TECHNICAL SERVICE BULLETIN

Classification: EM23-001	Reference: NTB23-034	Date: April 17, 2023
-----------------------------	-------------------------	-------------------------

COOLANT SMELL OR LEAK FROM COOLANT HOSE CLAMPS

APPLIED VEHICLES: 2022 LEAF (ZE1)
APPLIED DATES: Built from January 6, 2022 to March 31, 2022

Figure 1

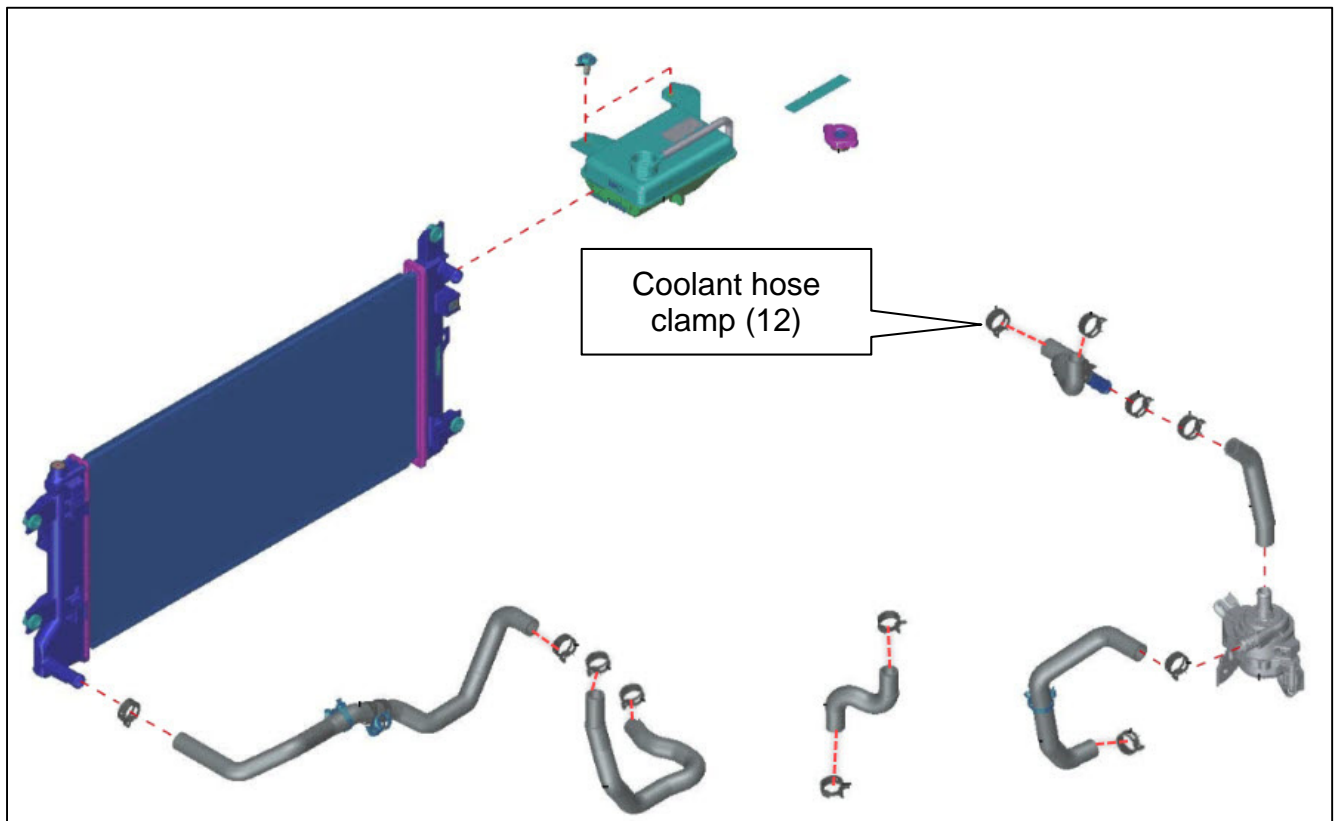
1. Replace all twelve (12) coolant hose clamps.

- Refer to the ESM: **ELECTRIC POWER TRAIN > HIGH VOLTAGE COOLING SYSTEM > REMOVAL AND INSTALLATION > RADIATOR - RADIATOR : Exploded View**
